BECHTEL
LOS ANGELES
ARIZONA NUCLEAR POWER PROJECT
PALO VERDE NUCLEAR
GENERATING STATION

ELEMENTARY DIAGRAM
SAFETY INJECTION SHUTDOWN CLG SYSTEM
CONTAINMENT SPRAY ISOLATION VALVES
J-SIA-HV-687 & J-SIB-HV-695

PALO VERDE NUCLEAR GENERATING STATION UNITS 1, 2 & 3
DRAWING CHANGE NOTICE (DCN)
JOB NO. 10407

DRAWING NO.	SHEET NO.	REV.	DCN NO.
13-E-SIB-024		2	2

SAFETY EQUIPMENT
INOPERABLE STATUS
* BY MCC VENDOR
ID S179 [S180]

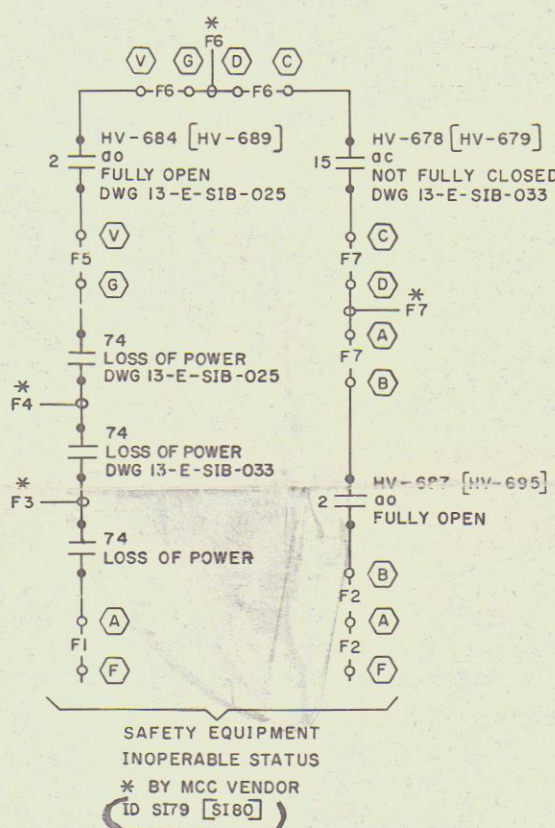
REASON FOR CHANGE: ICSB DRAWING REVIEW (TASK #35)

DESCRIPTION OF CHANGE
IN THE SAFETY EQUIPMENT INOPERABLE STATUS CIRCUIT,
CHANGE

FROM

TO

AFFECTED EQUIPMENT: VALVES J-SIA-HV-678 &
J-SIB-HV-679
12-11-81
